Cambridge Past, Present & Future
Wandlebury Country Park
Cambridge CB22 3AE
Phone 01223 - 243830
www.cambridgeppf.org

08/07/2022

Response to Cambourne to Cambridge Busway Environmental Impact Assessment - Public Consultation.

Section C - Childerley Gate

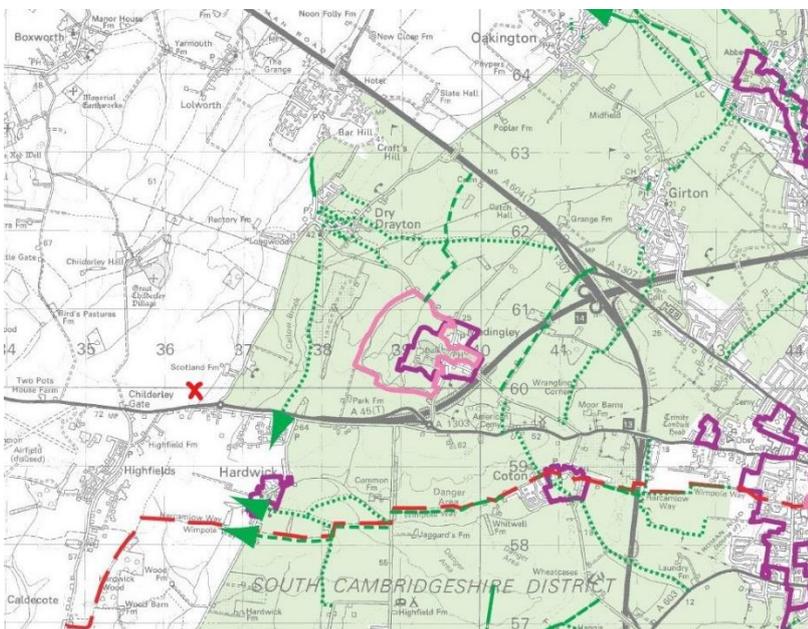
The route through this section would destroy landscaping/habitat that was created to offset the impact of the construction of the A428. There would be a loss in biodiversity.

We wish to raise concerns about the proposal to create an island of new habitats surrounded by busy roads at the eastern section, between the A428, St Neots Road and existing balancing pond. Any wildlife taking up residence here would face the risk of being killed on surrounding major roads and the ecological benefits are likely to be reduced by the physical barriers and ecological severance created by the roads. We are particularly concerned about plans to locate a SUDS pond here, which will attract wildlife and could lead to the deaths of a large number of amphibians attempting to cross busy roads to breed. In our view, this proposal represents poor ecological planning, and we would encourage you to instead consider creating new

habitat in a location which is better connected to other natural habitats and where the wildlife that moves in is not at high risk of being killed. We are aware that there is already a SUDS pond in this location that was created as part of the A428 but we advise you against repeating that mistake.

However, it may be appropriate in this location to plant trees in order to have a mitigating impact on traffic noise and transport infrastructure – as well as some wildlife benefits.
